**Figure 2.1n**  
**Infrastructure Design Review**  
**- Turbine 16**

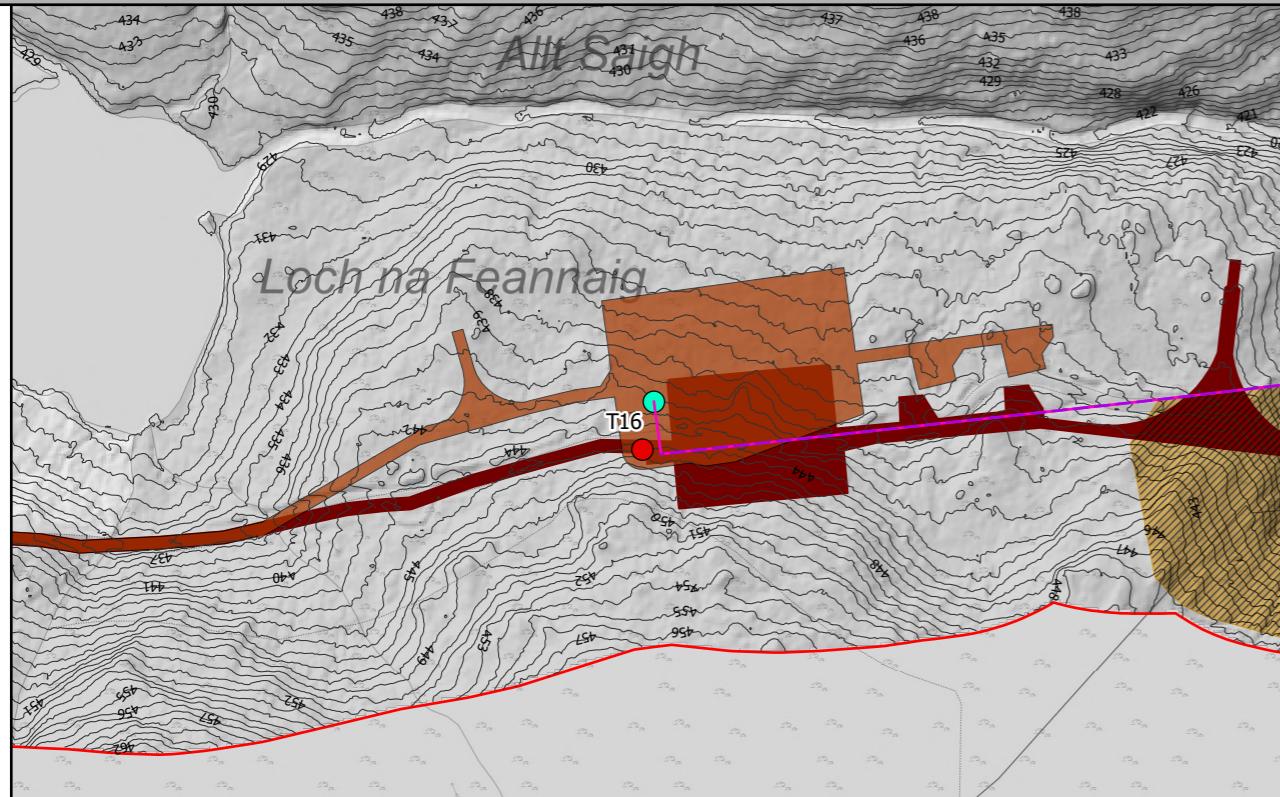
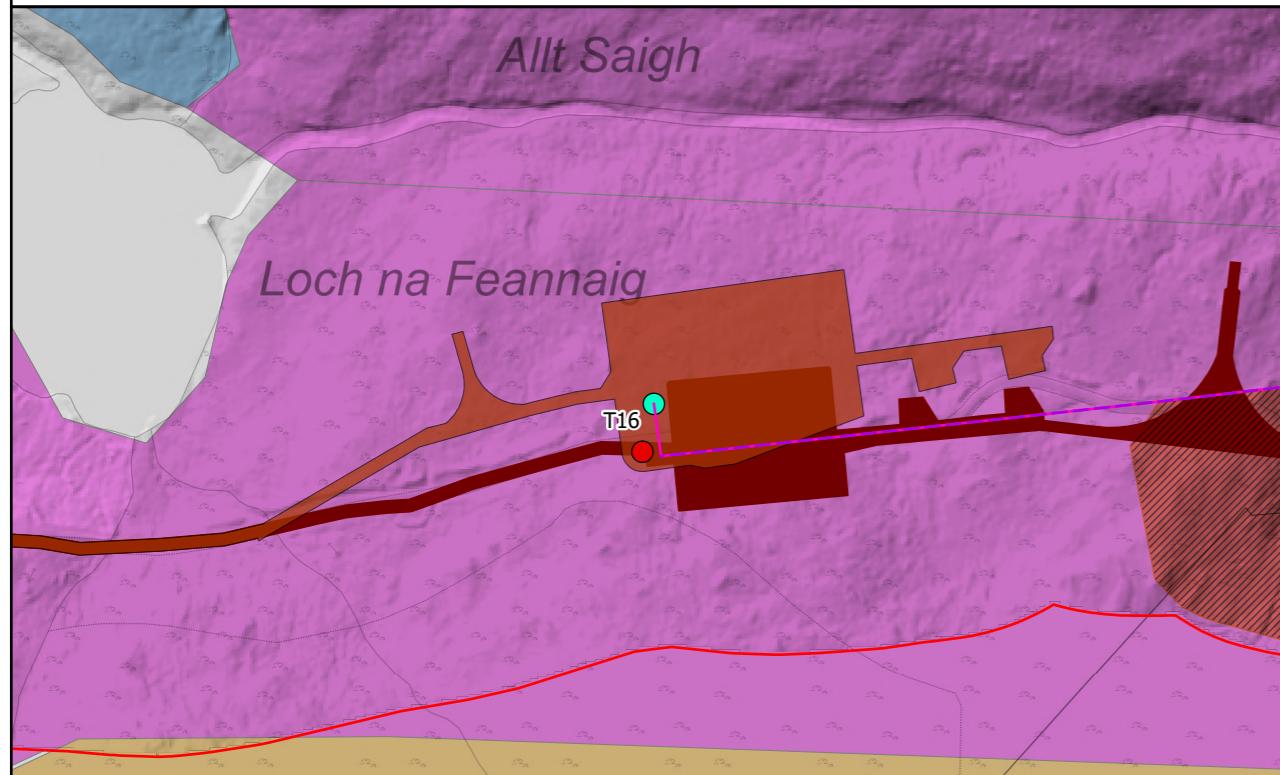
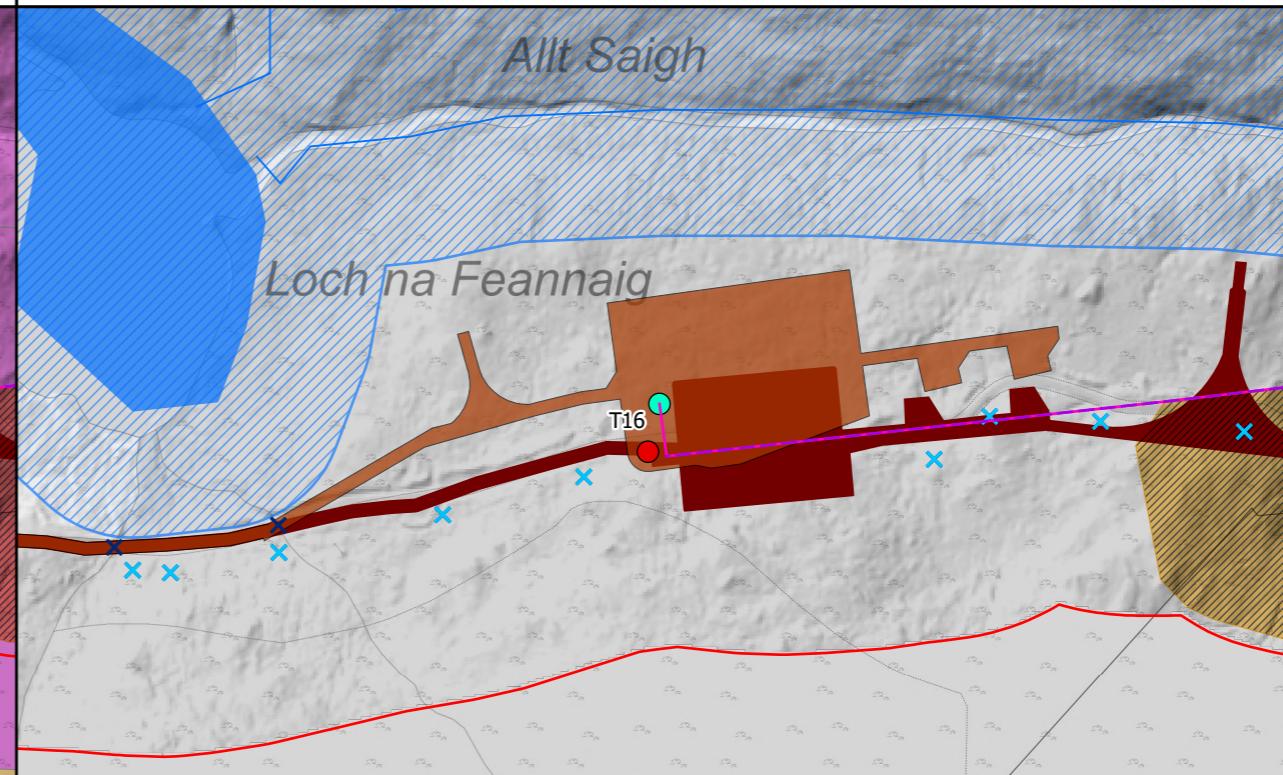
**T16: Reason for Moving:** The proposed location of the turbine has not moved significantly from the consented position. The small move in location has been driven by the need to accommodate the larger hardstand for the turbine being considered for this project. Suitable distance from the communication mast link has been maintained to provide the opportunity to remove the need for a new mast east of this turbine location.

**Engineering:** The hardstand has been increased in size towards the North to take advantage of the relatively flat topography of the section between the Allt Saigh to the north and the existing Hydro track, minimising required earthworks and avoiding the steeper hill to the South.

**Geology Impacts:** The consented and proposed infrastructure is located predominantly in shallow peat and some impact on medium peat depths. The proposed layout removes the need for a loaded turning head and approximately 150m of track to the east of the turbine. Should a new communication mast be required a lower capacity road would be required to get out to the mast location. All proposed infrastructure is located in the consented 50m micrositing buffer.

**Ecology Impacts:** As with the current consented infrastructure, the new layout is entirely within Wet Heath (M15c).

**Hydrology Impacts:** The proposed location is outside the 50m water buffers.
